28 May 2019

Contact: *Stuart Little*
Telephone: *02 9865 2449*
Our ref: *D2019/51119*

I refer to the email dated 3 May 2019 from Council seeking Pre-Gateway comments on a Draft Planning Proposal to rezone land adjacent to Dossie Street Goulburn, and to remove the 100ha minimum lot size (MLS) restriction.

Figure 1. Drainage Features and Catchment Area for Dossie Street Planning Proposal Site.

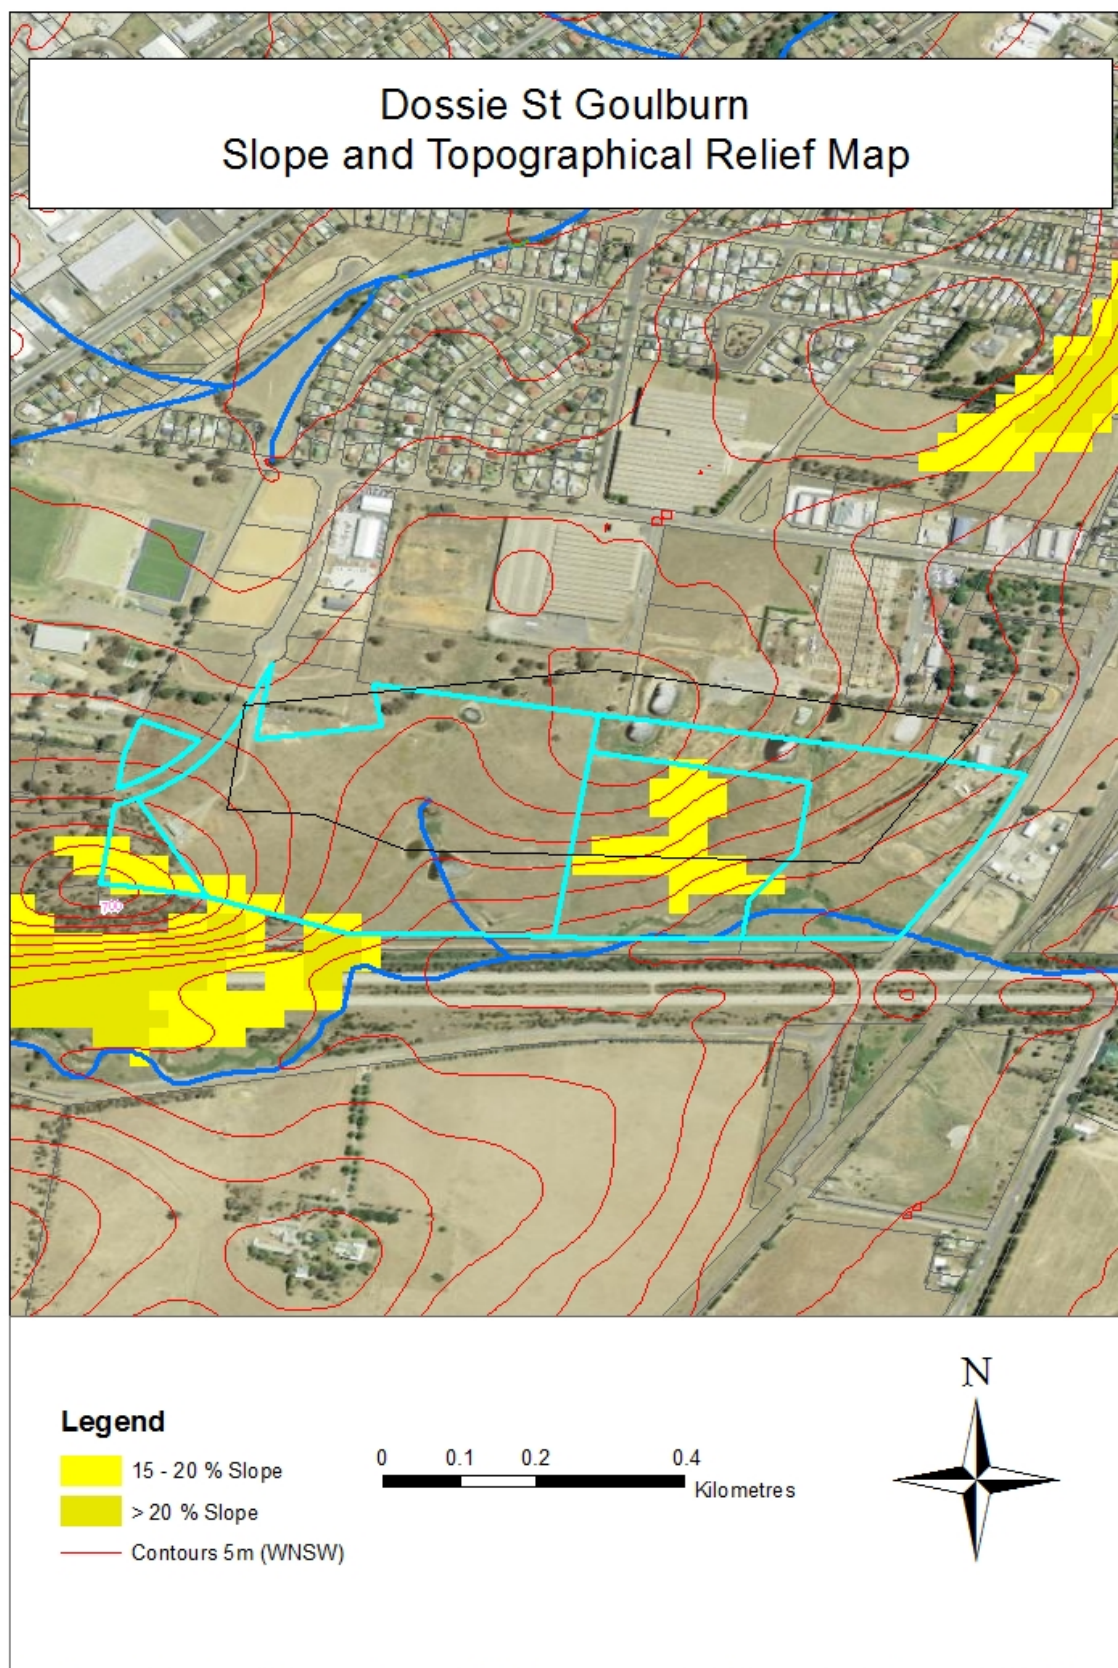
These two northern ponds fall within the catchment of the unnamed creek that occurs at the south of the site and exits Lot 1 DP 1034565 in its south-eastern corner (Figure 1). The ponds therefore present a potential pollution risk for the Lot, downslope areas, and the creek itself. The ponds are likely to require remediation to remove contaminated water and other material before any development occurs. WaterNSW considers this to be a site constraint and a potential water quality risk, which should be discussed and addressed in the Planning Proposal.

The Draft Proposal provides little information on natural drainage features of the site including on the eastern two allotments. The first order watercourse described above drains into a second order watercourse that runs along the southern boundary of Lot 2 and then crosses into the southern portions of Lot 3 DP1008818 and Lot 1 DP1034565 (Figure 1).

Most of the subject site forms part of the catchment of this unnamed creek. Importantly, at its south-eastern exit point from the eastern-most lot, the catchment area of the creek is about 250 ha (Figure 1). The site is therefore likely to experience high flows during storm events and may be flood-prone, which may limit the development capacity of the two eastern allotments.

WaterNSW considers that the Planning Proposal should identify and discuss all the water features and water quality risks. This should include a map showing the natural and artificial water features occurring on the site, and any floodplain or flood-prone areas.

Figure 2. Slope and Topography for Dossie Street Planning Proposal

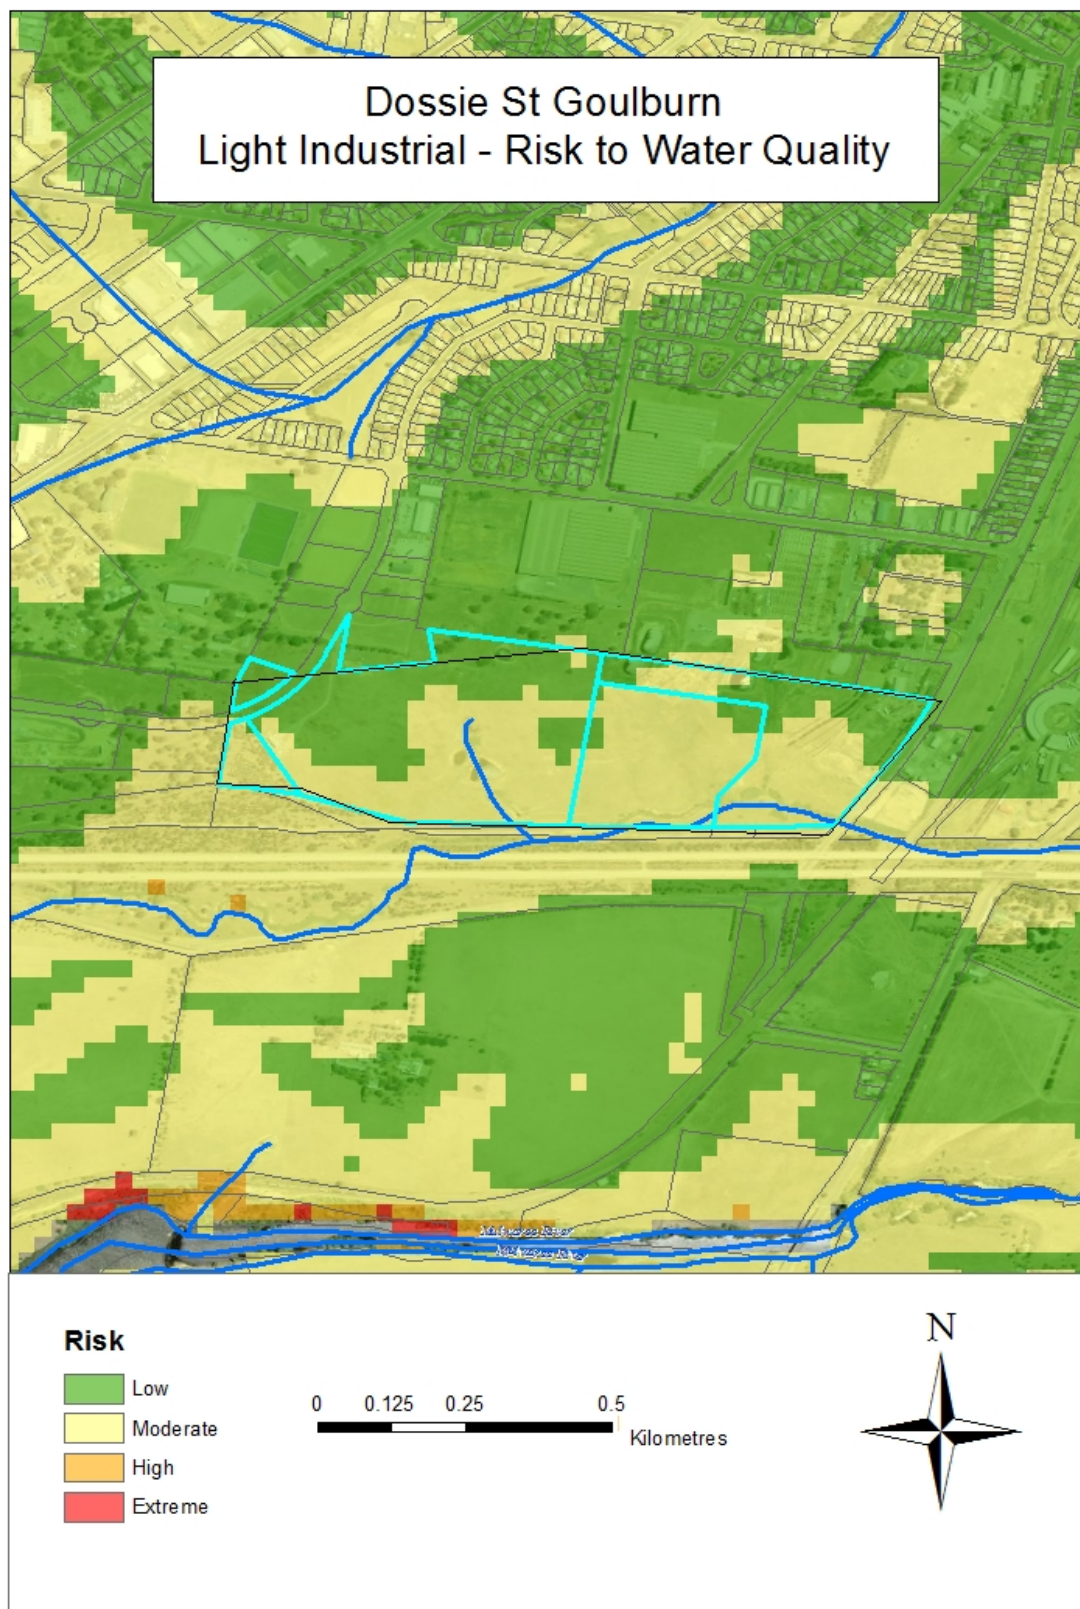
There appears to be a drop of some 40m over the site from the north to the north-eastern corner. Slopes are particularly steep for Lot 3 DP1008818 (15-20%) (see Figure 2). In general, the site of the Planning Proposal is steeper than the existing IN1 General Industrial land that lies to its north.

The implication of the slopes are such that significant earthworks are likely to be required to make reasonably-sized flat areas for industrial land uses proposed. This in turn is likely to result in significant areas of hardstand creating impervious surfaces affecting stormwater runoff.

Figure 3. Strategic Land and Water Capability Assessment: Light Industrial Development Risk to Water Quality

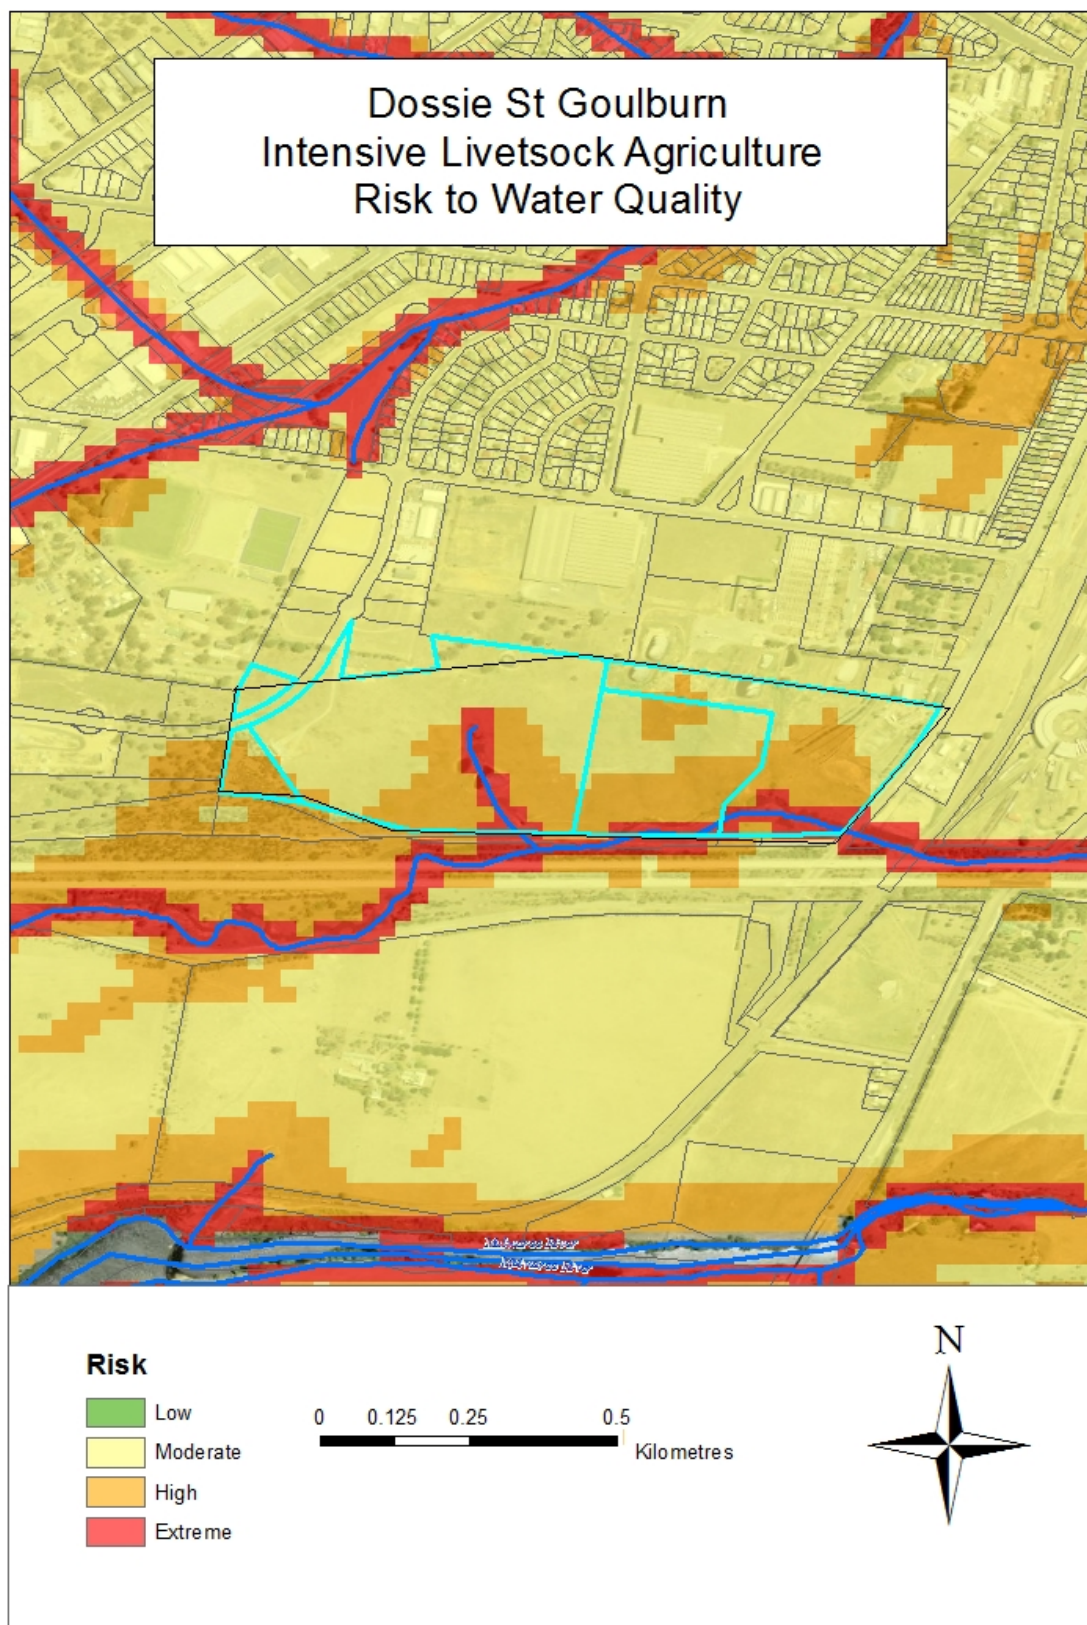
For the areas proposed to be zoned IN1 General Industrial, WaterNSW has applied the SLWCA for Light Industrial Development. While it indicates that the site has a Low to Moderate risk to water quality (Figure 3), WaterNSW considers this to be an underestimate of the water quality risks as the important Stream Proximity factor appears to be overshadowed by other inputs.

Figure 4. Strategic Land and Water Capability Assessment: Intensive Livestock Industries Risk to Water Quality.

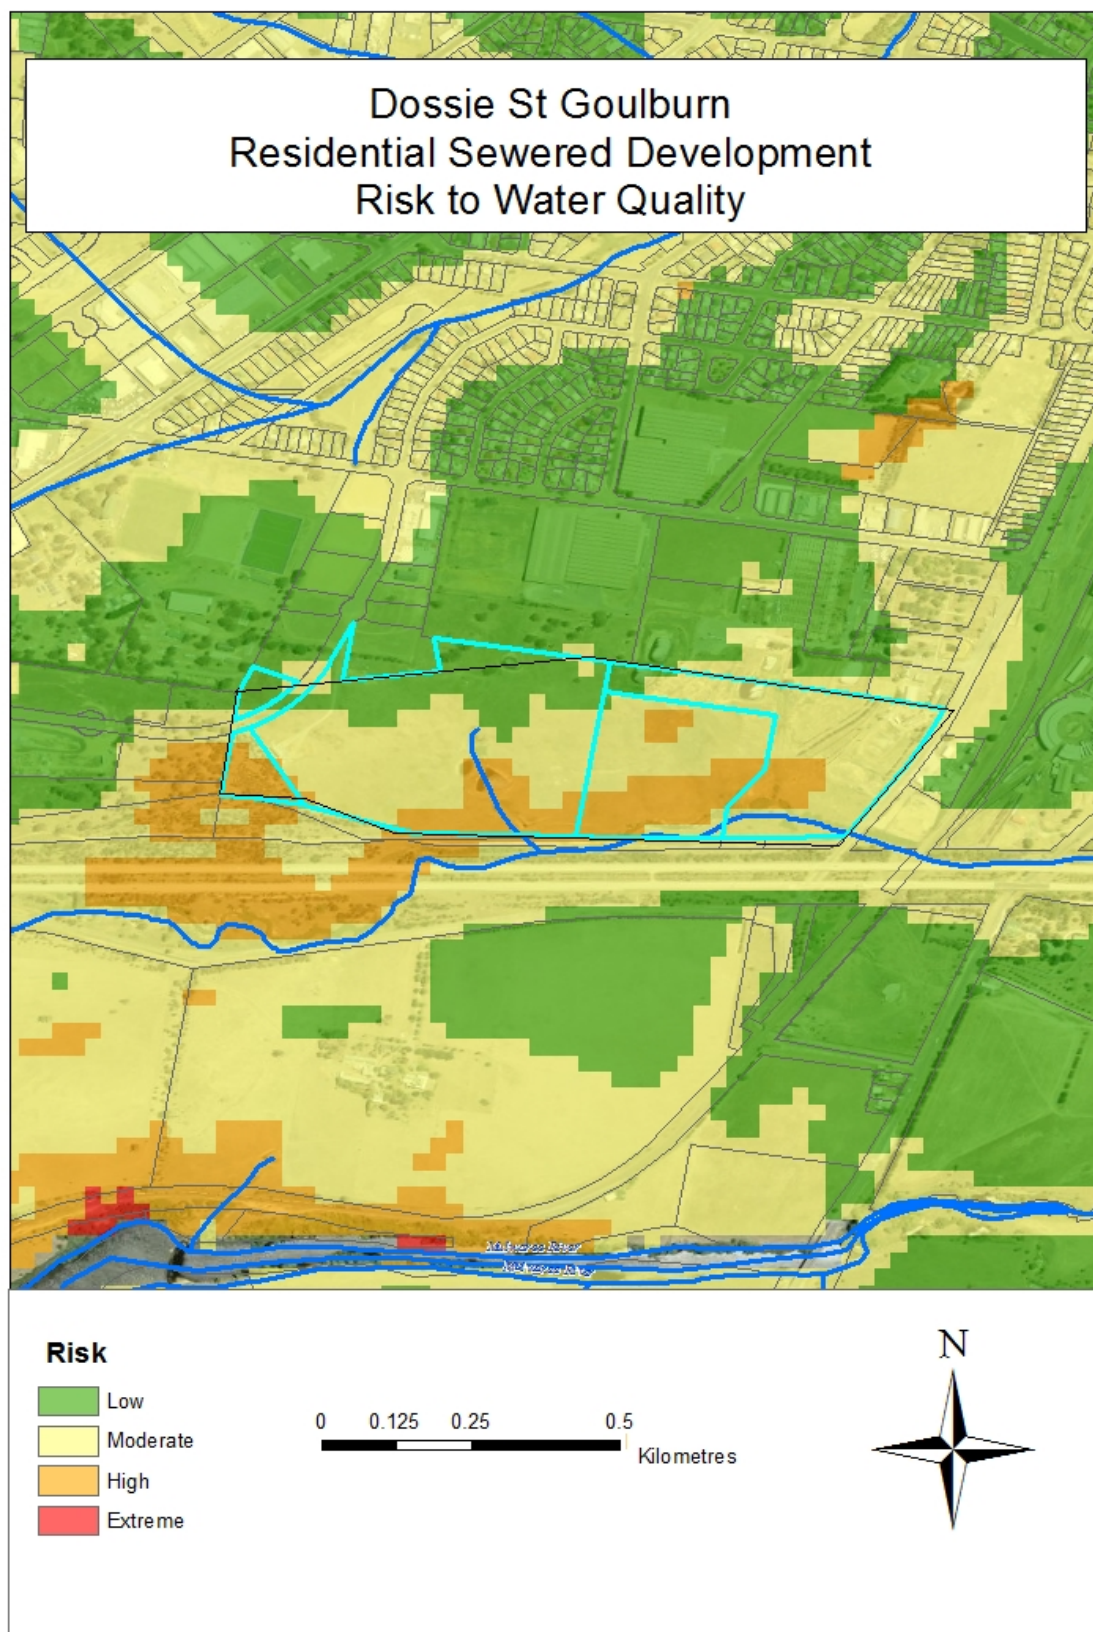
Under the IN1 zone, agricultural uses such as 'stock and sale yards' and 'intensive livestock agriculture' (e.g. poultry farms) would be permissible with development consent. For this reason, we have included a SLWCA for intensive livestock industries (Figure 4).

This reveals that the risk varies from Moderate in the north of the site to Extreme in the south where the southern boundary generally follows the creek line. High and Extreme ratings also occur in the mid to lower section of Lot 2 DP 1238214, along the drainage line that feeds into the creek. We would encourage Council to explore way of limiting intensive livestock agriculture from areas where the High and Extreme rating occurs.
